**UN Regulation No. 92 (Replacement Exhaust Silencing Systems for Motorcycles)**

## **Proposal for a Supplement 1 to the 02 series of amendments to UN Regulation No. 92**

**Submitted by the experts from Germany, the Kingdom of the  
Netherlands, Switzerland, the United Kingdom of Great Britain and  
Northern Ireland and the European Commission\***

*Figure 1: Exhaust silencer*

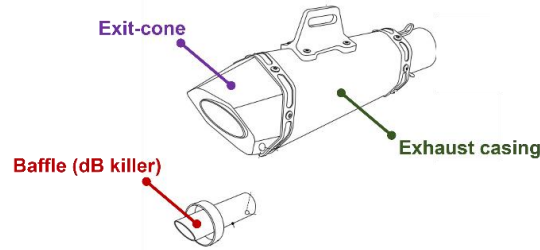
"2.8. **“Exit-cone”** means the final part of the exhaust silencing system outlet through which exhaust gases exit into the air (see figure 1).
